ADDENDUM #1

Issue Date: September 16, 2019

Solicitation: RFP #2019020 – Remove and Replace Two (2) Welded Steel Water Treatment Vessels

PROJECT
C–4500HT MEDIA INSTALLATION DETAIL

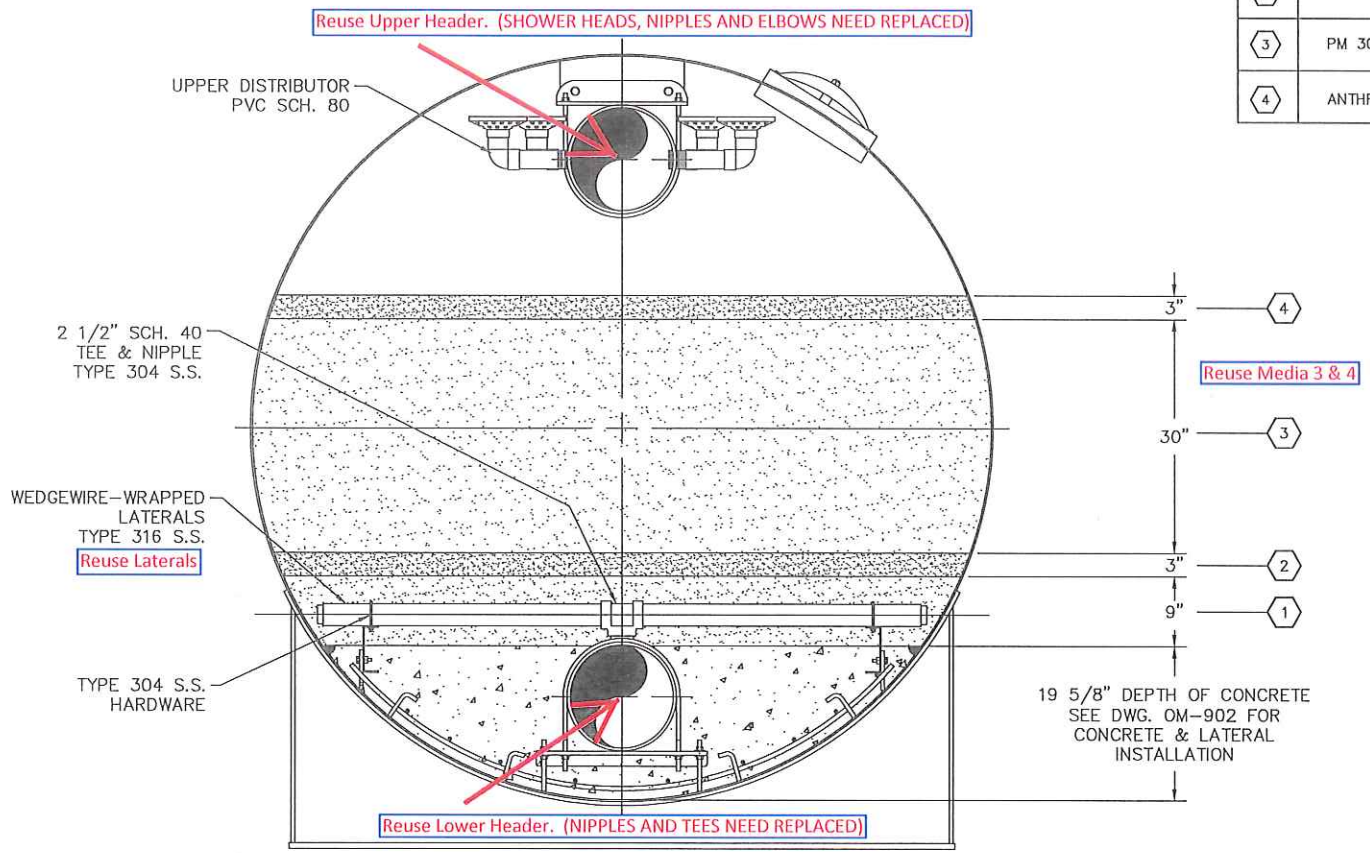
2. **Q.** Could you provide specifications and/or vendor information on the four types of media contained within the vessels (including any analytical data and previous disposal information)?

A. Media 1 – PM 80-120 (14,500 LBS.) On previous jobs, the contractor handled the disposal
   Media 2 – PM 250 (5,000 LBS.) On previous jobs, the contractor handled the disposal
   Media 3 – PM 300 (49,000 LBS.) Remove, place in super sack and reinstall
   Media 4 – Anthracite (2,028 LBS.) Remove, place in super sack and reinstall
   Contact Archie with Pureflow for more information/questions about media (Archie MacDonald 562-547-3887)

TYPICAL LATERAL ATTACHMENT

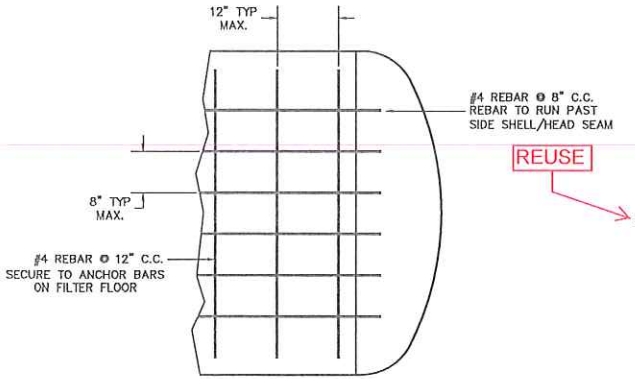
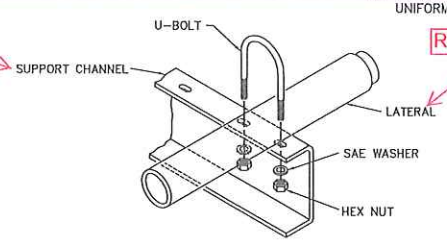
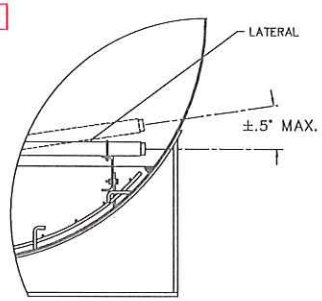
5. **Q.** Please clarify which portions of the internal piping will be reused and which portions will be replaced.

A. The upper and lower headers and laterals will be reused. The nipple, elbow and shower heads on the upper header will be replaced and on the lower header the stainless steel nipple and tee will be replaced (see attached plans).

REUSE

REUSE
